UNITED STATES PATENT AND TRADEMARK OFFICE

APPLICATION NO.	FILING DATE	FIRST NAMED INVENTOR	ATTORNEY DOCKET NO.	CONFIRMATION NO.
10/635,363	08/06/2003	Alin Theodor Iacob	100-22100	8885
33402	7590	05/02/2005	EXAMINER	
LAW OFFICES OF MARK C. PICKERING P.O. BOX 300 PETALUMA, CA 94953			TRAN, TAN N	
			ART UNIT	PAPER NUMBER
			2826

Office Action Summary	Application No.	Applicant(s)	
	10/635,363	IACOB, ALIN THEODOR	
	Examiner	Art Unit	
	TAN N. TRAN	2826

DETAILED ACTION

FIG. 1(b)

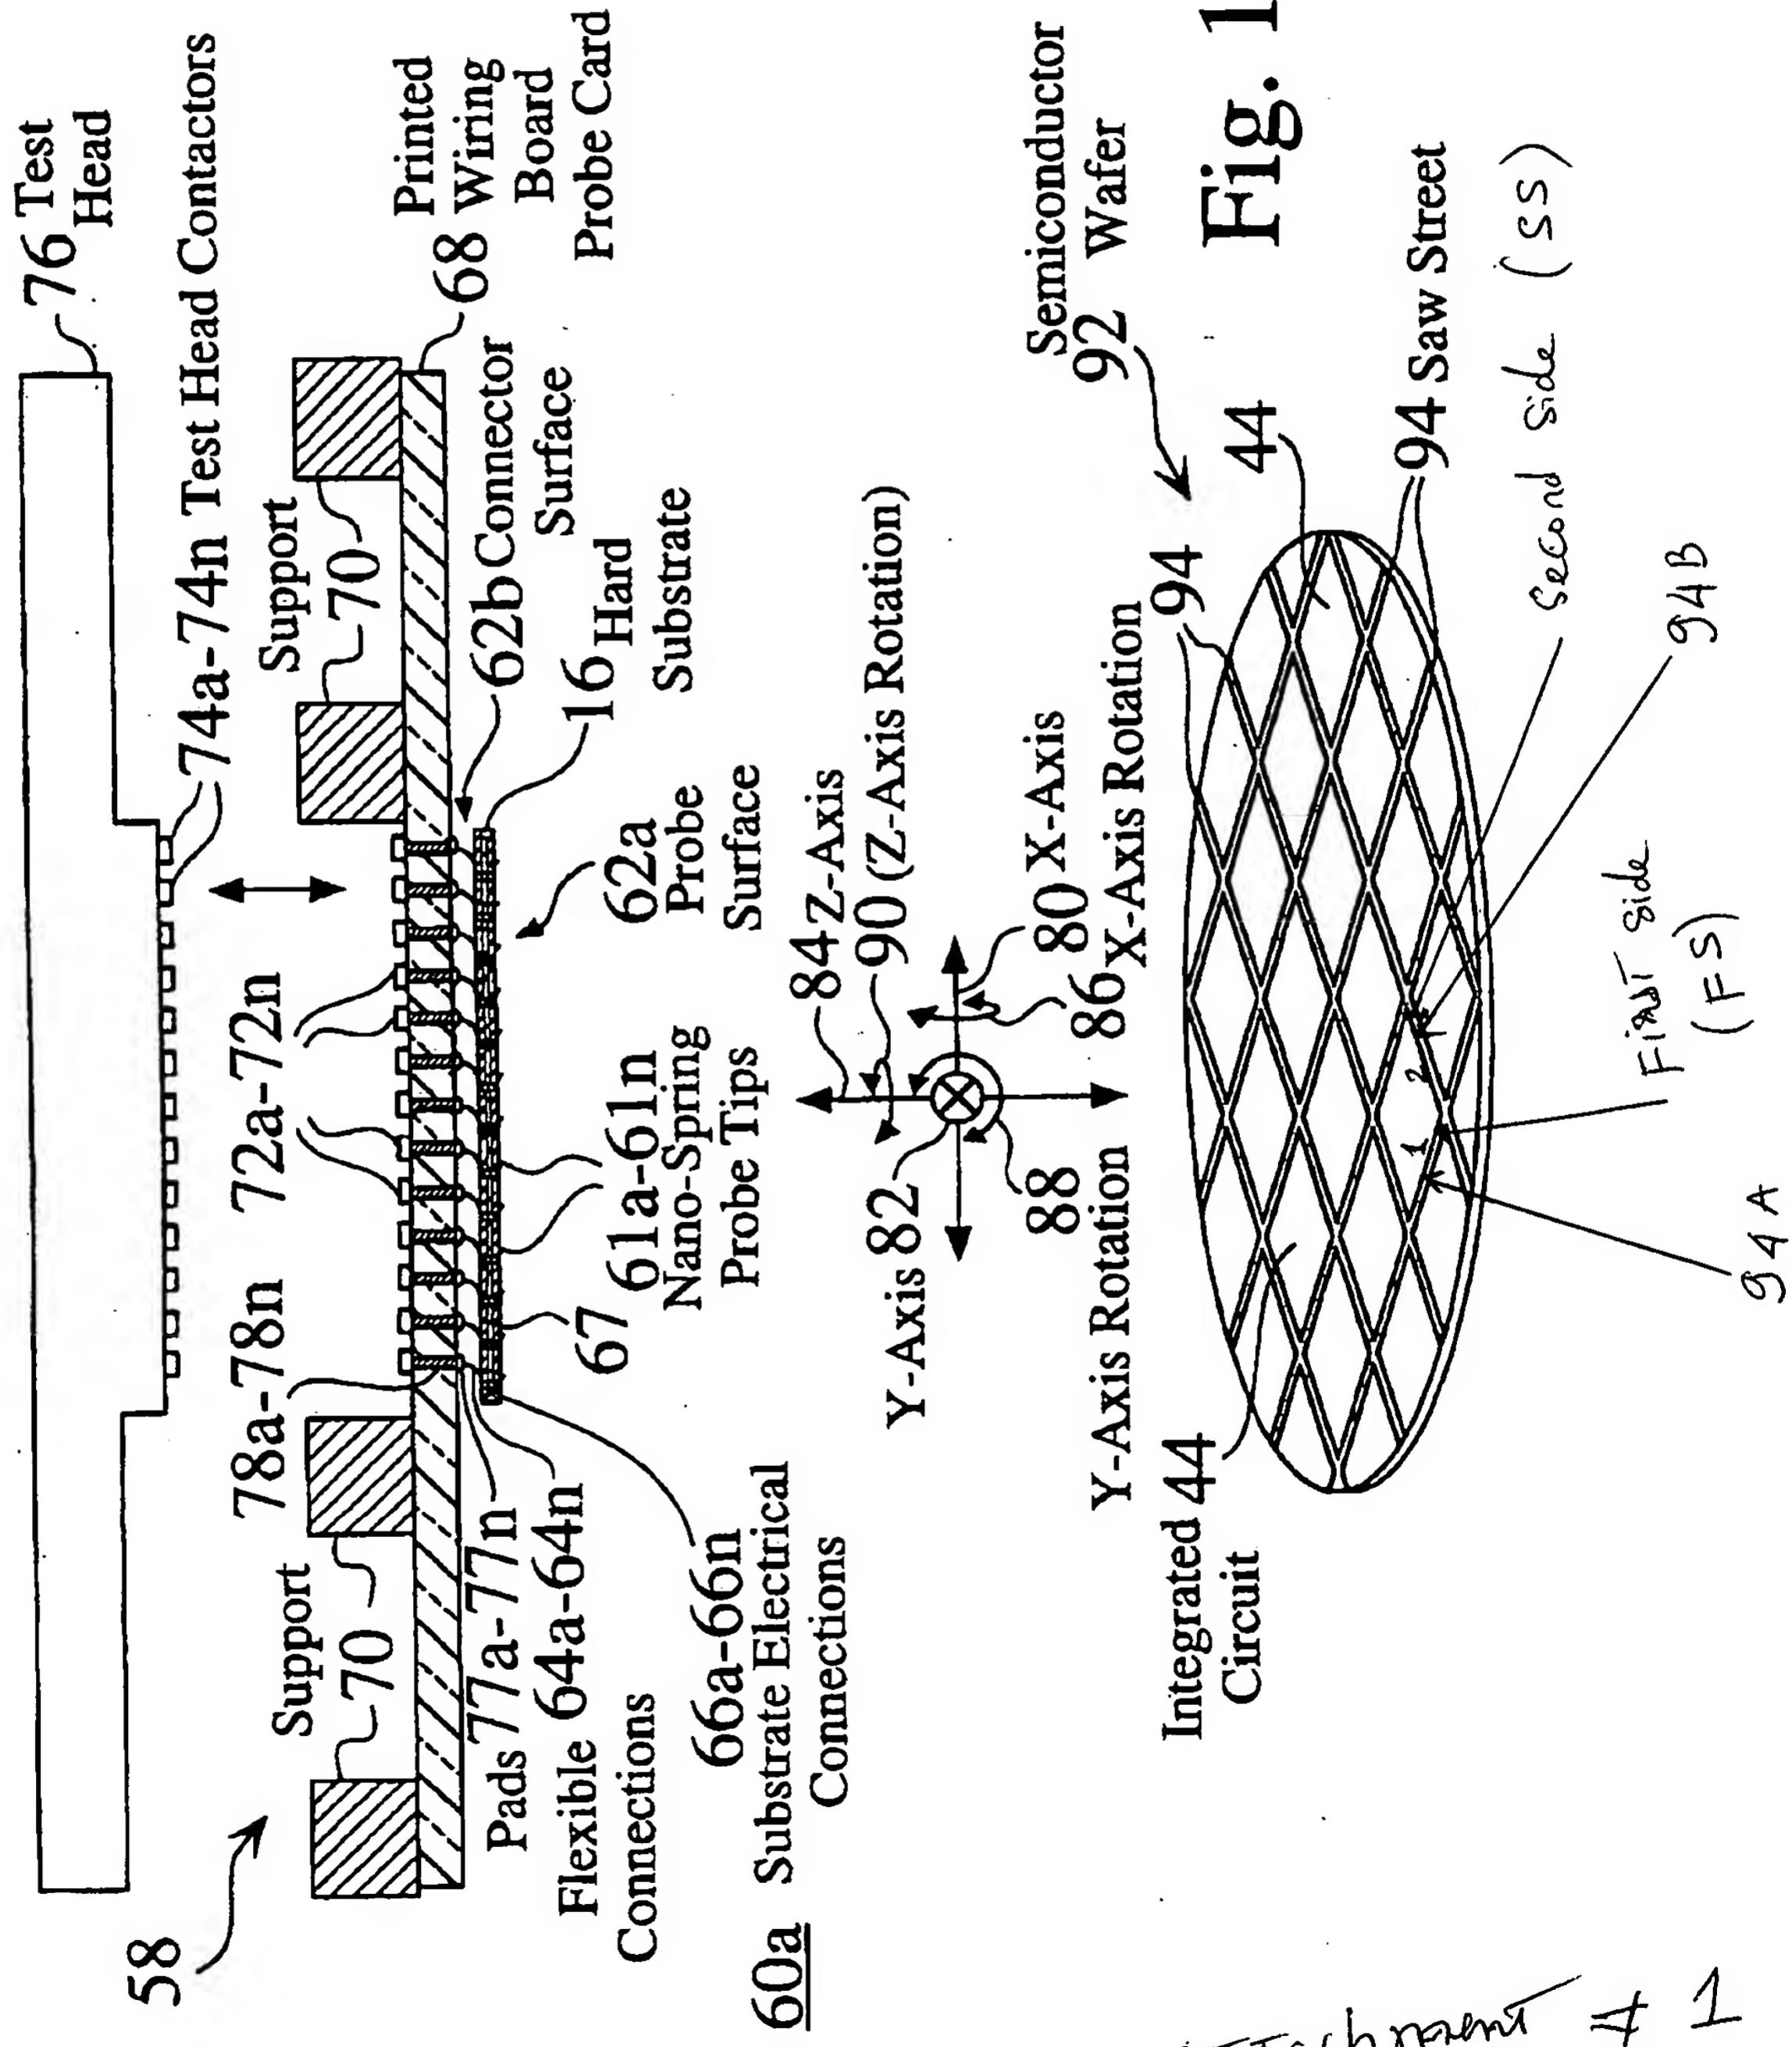
However, Byrd et al. discloses a first conductor trace 1 formed in a first saw street (AA), the first conductor trace 1 not crossing the first saw street (AA); and a second conductor trace 3 formed in the first saw street (AA), and the second conductor trace 3 not crossing the first saw street (AA), wherein the first saw street (AA) formed between the first and second semiconductor circuits 5; and wherein the first and second conductor traces (1,3) extend across the wafer. (Note attachment #2, lines 27-32, column 3, fig. 1(b) of Byrd et al.).
